AENC-NG-CNS-REP-0292

Norwich to Tilbury

Document: 8.9.1 Applicant's Responses to First Written Questions

Planning Inspectorate Reference: EN020027

Index of Multiple Deprivation, 2025 (Source: [Overall \(IMD\)](#) | [Local Deprivation Explorer](#))

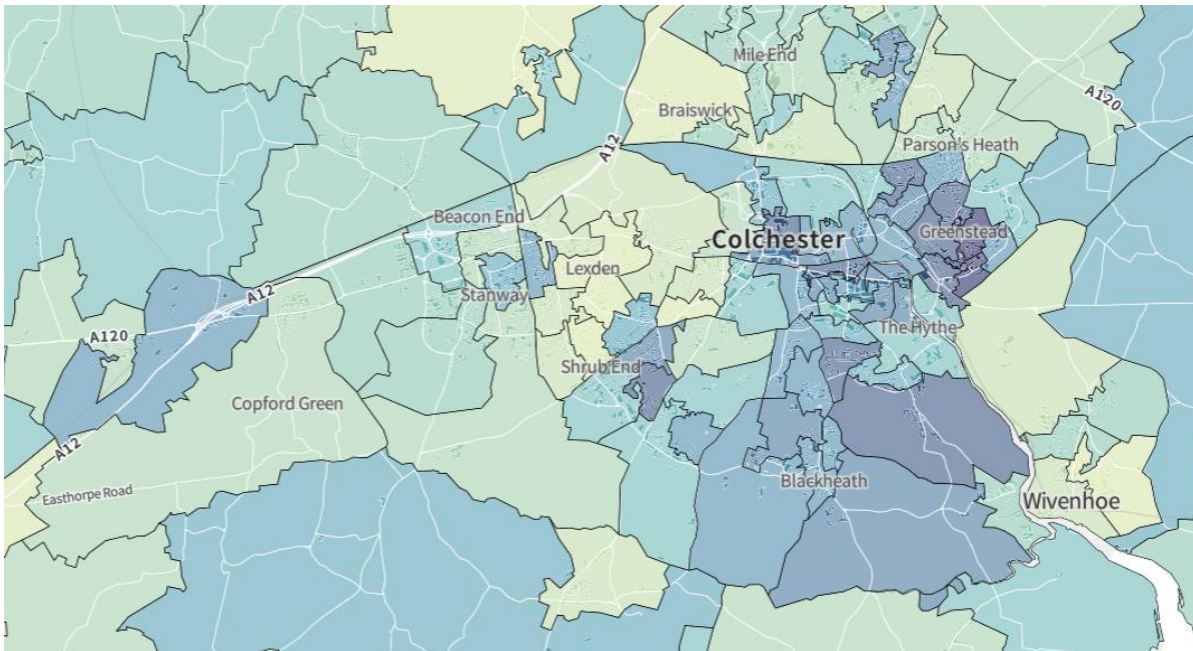
Reference	Question	Applicant's Response
	Deprivation (IMD) and Lower Layer Super Output Area (LSOA) level data for Colchester. - Integration of local health and wellbeing strategies and Integrated Care System Joint Forward Plans. - Inclusive engagement measures for language-vulnerable communities. - Consideration of cumulative mental health impacts through Mental Wellbeing Impact Assessment workshops. - A robust Health and Wellbeing Monitoring Framework with enforceable commitments. The applicant is requested to respond to each of the requests identified, taking account of the justification and background in the preceding paragraphs of the LIR and provide commentary on how these can be addressed including the information and assessment requested or explain why it is not necessary. Note: Your response to updating the IMD, as set out in [REP1-132] is noted. However, the ExA would ask what evidence has been put forward to substantiate there is no need to update the document with the most up to date data. In the absence of adequate evidence, you must revisit the relevant	submitted) shows that, as a whole, deprivation levels have reduced for the Colchester City Council area, with fewer neighbourhoods now ranking among the most deprived in England. The images below show deprivation by LSOA for 2019 (top image) and 2025 (bottom image). The darker colours indicate areas of higher deprivation.  Index of Multiple Deprivation, 2019 (Source: Indices of Deprivation 2015 and 2019)

chapter of the ES and address any changes as a result of the IMD being updated. (Also see question SET 1.1 below).

Appendix A. Supplement 1 - GEN1.14 & DES1.8 – EACN and customer connection proposals with Landscape proposals

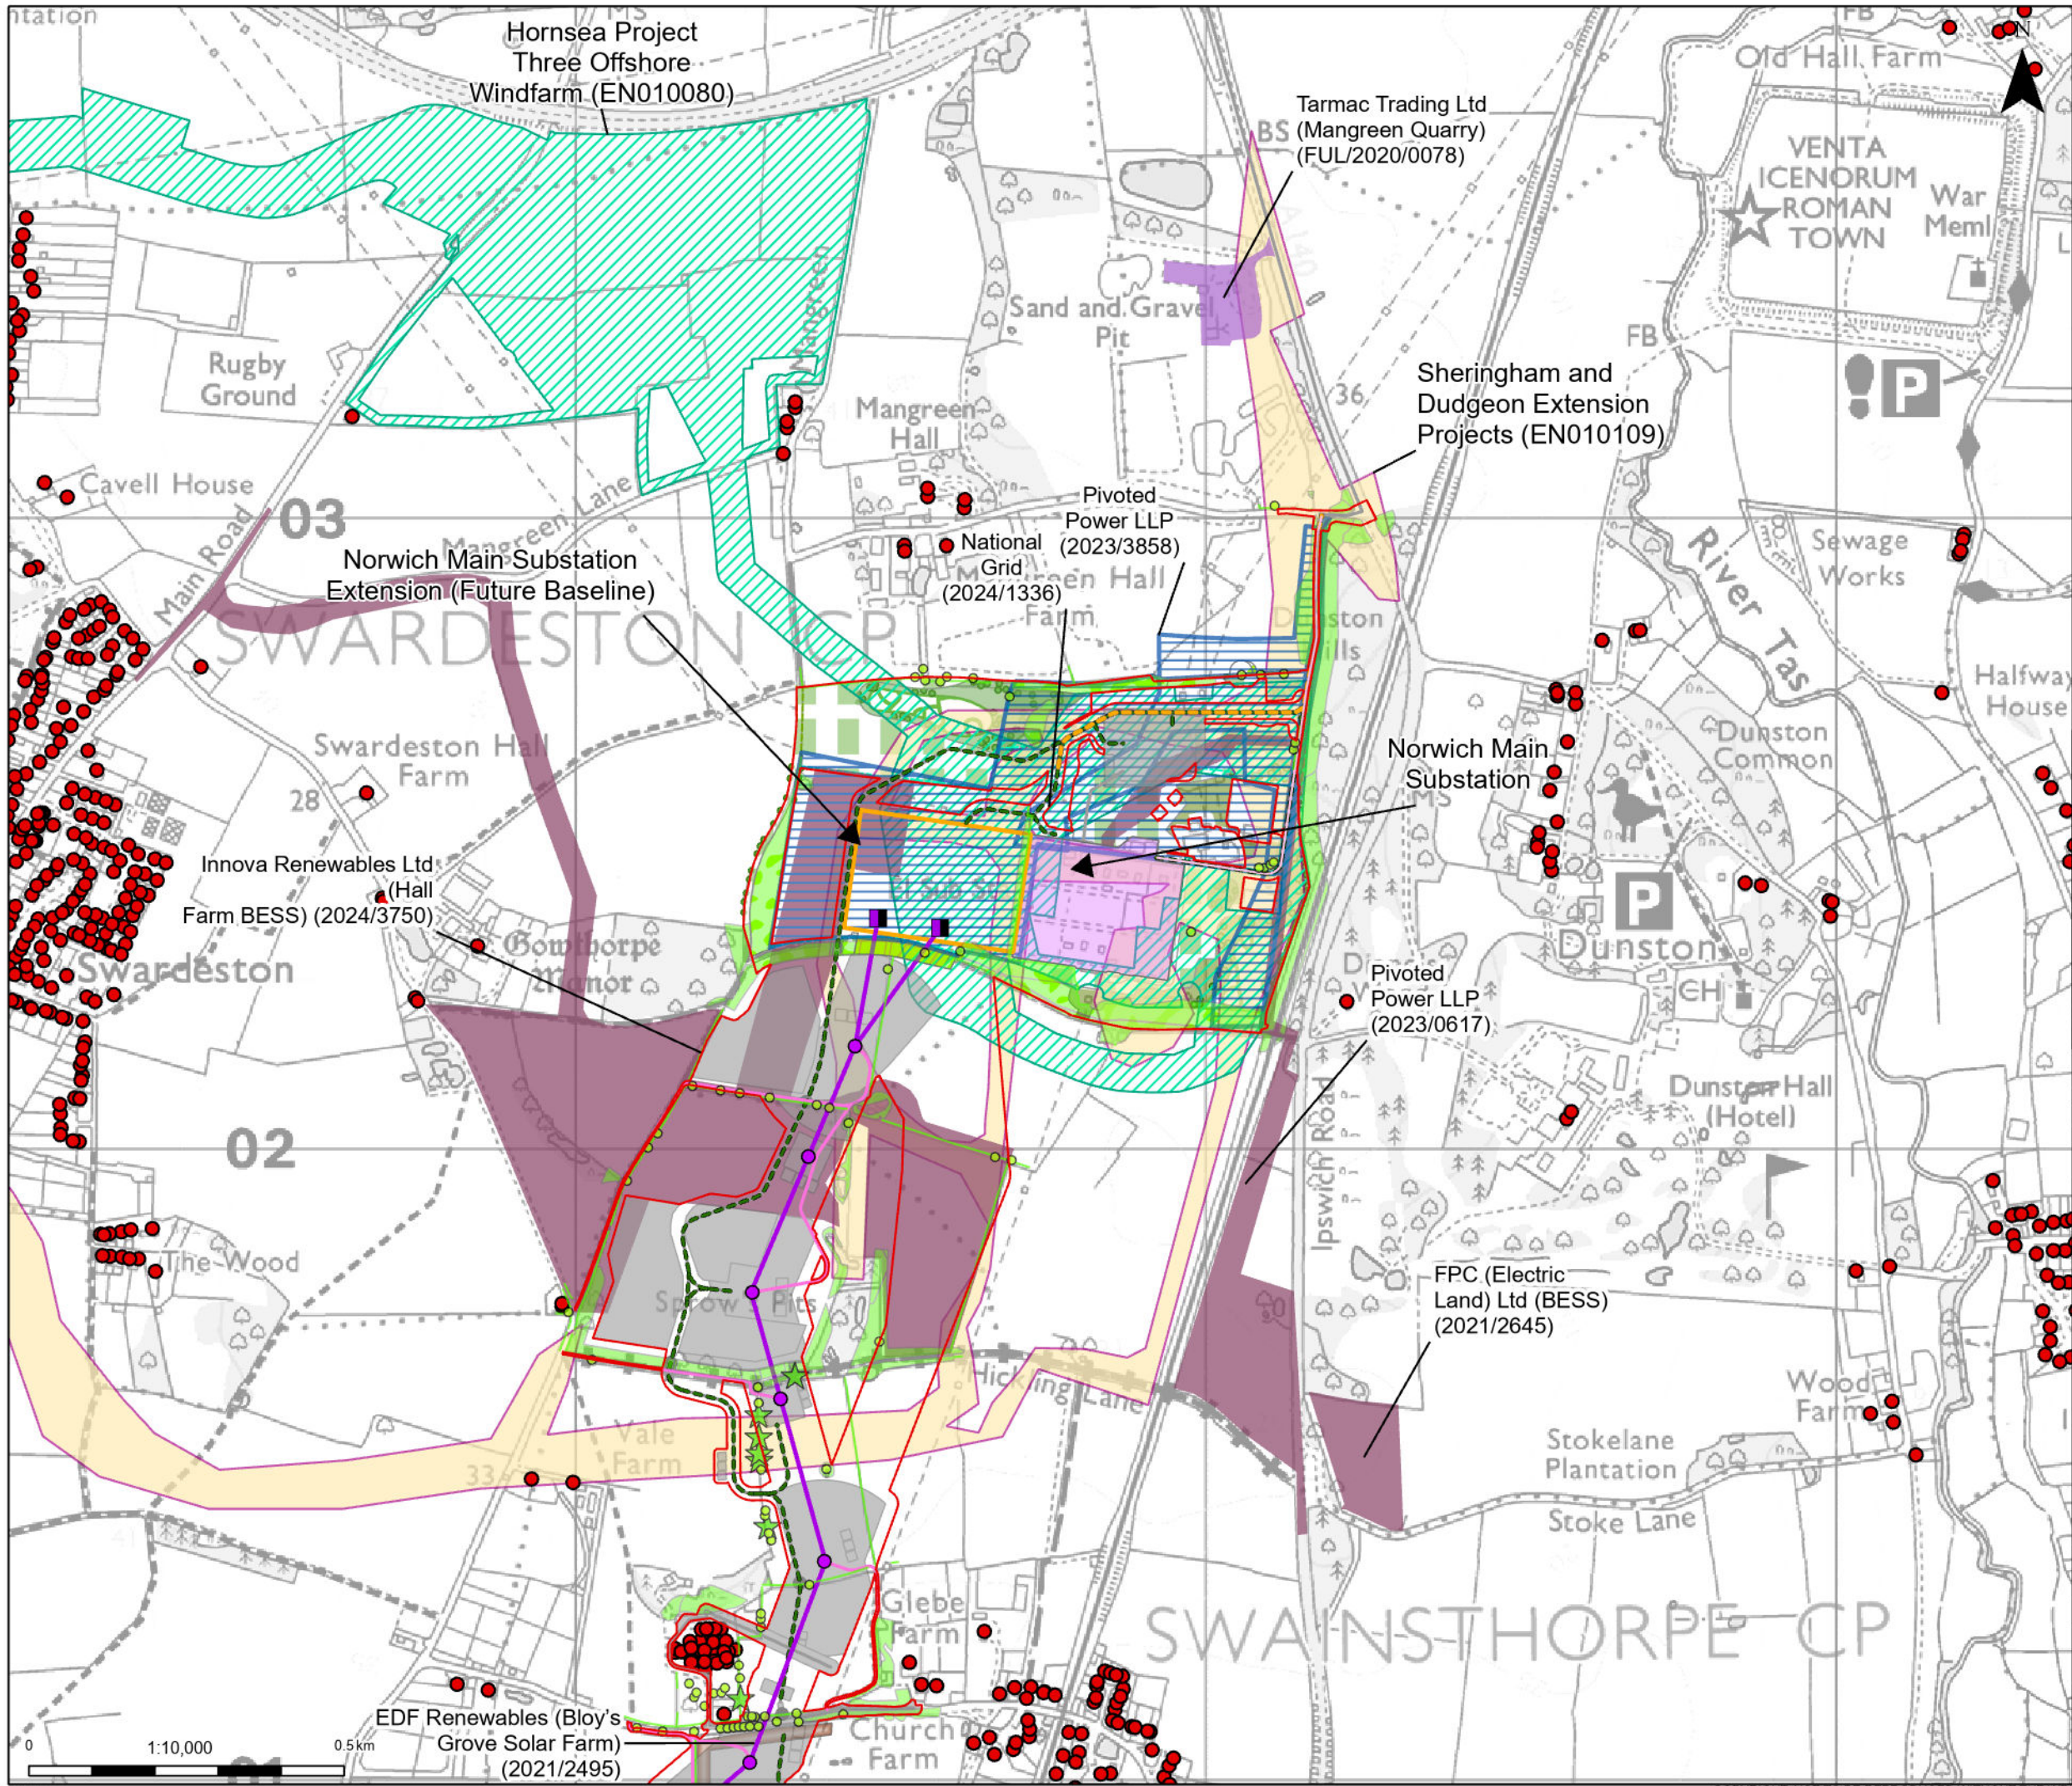
GEN 1.14	East Anglia Connection Node (EACN) substation site and nearby	The Applicant has provided the requested plan in Appendix A to this document. As suggested by the ExA in question DES 1.8, the Applicant has combined the plan
